HISTORIC AND DESIGN REVIEW COMMISSION

April 17, 2019

HDRC CASE NO: 2019-178
ADDRESS: 318 REFUGIO ST
LEGAL DESCRIPTION: NCB 714 BLK 11 LOT N 51.5 FT OF 5
ZONING: RM-4,H
CITY COUNCIL DIST.: 1
DISTRICT: Lavaca Historic District
APPLICANT: Nataly Jennings
OWNER: Nataly Jennings
APPLICATION RECEIVED: March 28, 2019
60-DAY REVIEW: May 27, 2019
CASE MANAGER: Adam Rajper
REQUEST:

The applicant is requesting a Certificate of Appropriateness for approval to replace the existing front yard picket fence with a new 4-foot tall galvanized steel cattle panel fence and driveway gate.

PLOT (SITE) PLAN

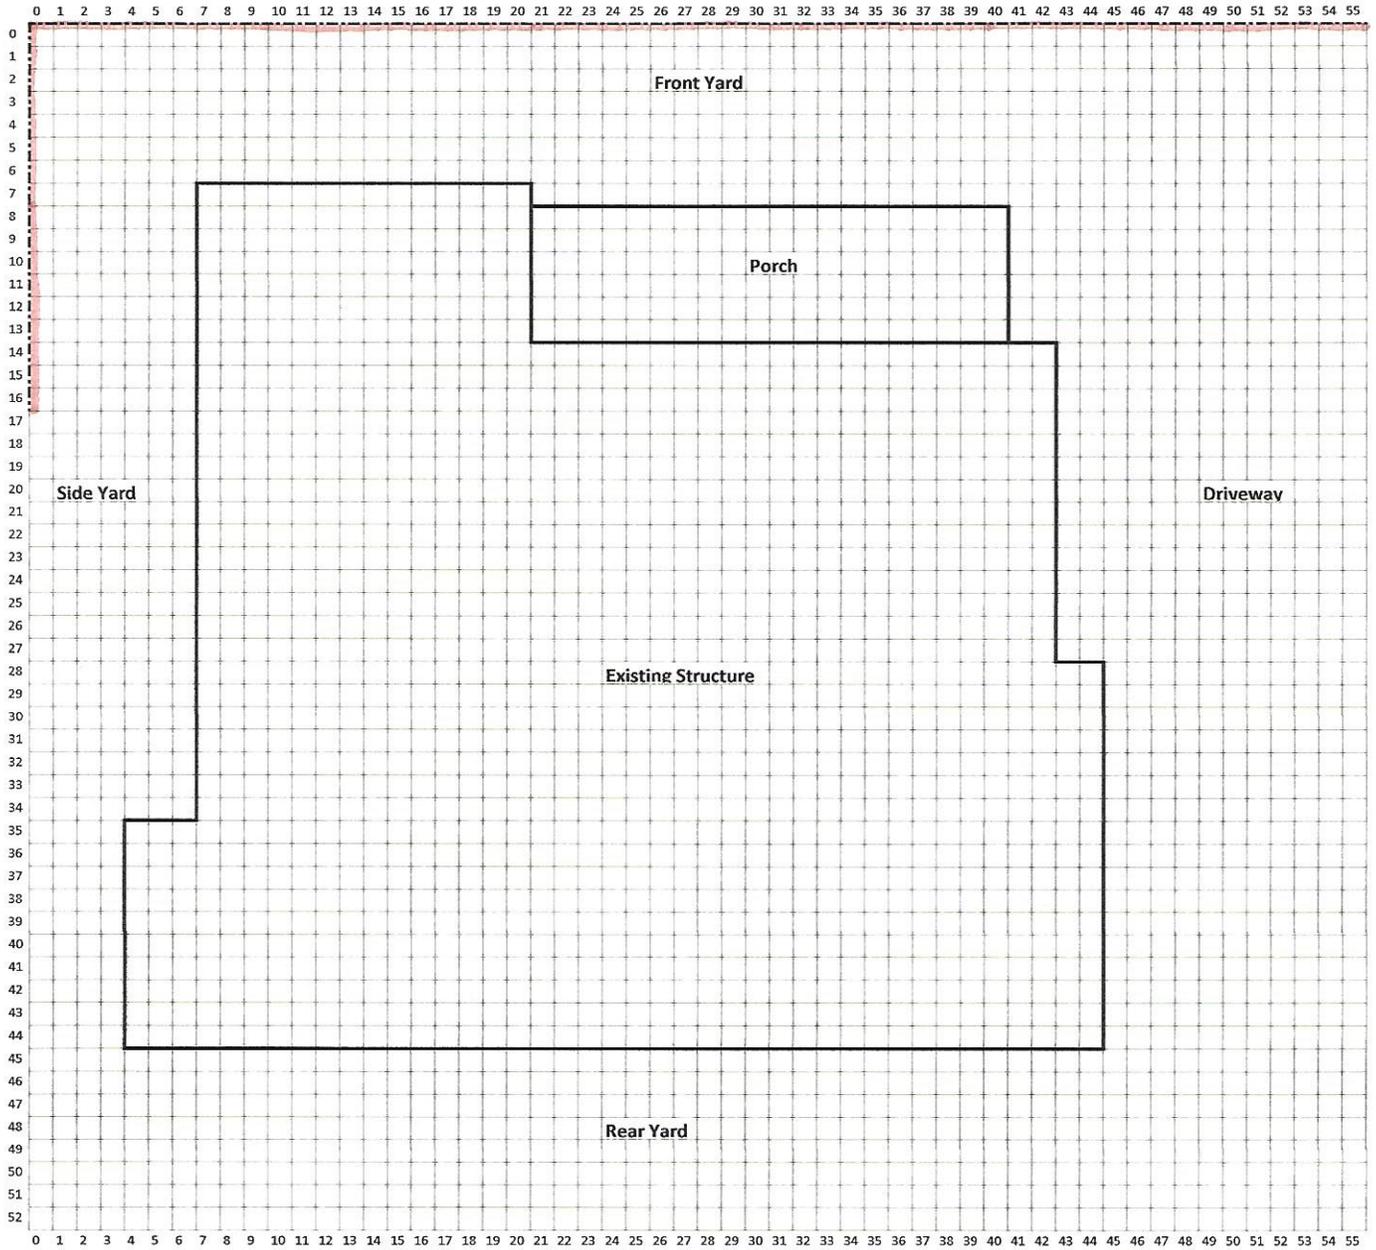
- c. FENCE LOCATION – The applicant has proposed to install a new fence that spans across the driveway instead of turning at the driveway to meet the corner of the house. According to the Historic Design Guidelines, new front yard fences should follow historic fence placements in the district. Staff finds that the fence should turn at the driveway to meet the corner of the structure, rather than spanning across the driveway as proposed.

- i. That the fence turn at the driveway to meet the corner of the structure and the driveway gate, if included, be set back behind the front façade plane of the structure, as noted in finding b. The applicant is required to submit updated documents that reflect this change to staff for review and approval prior to receiving a Certificate of Appropriateness.
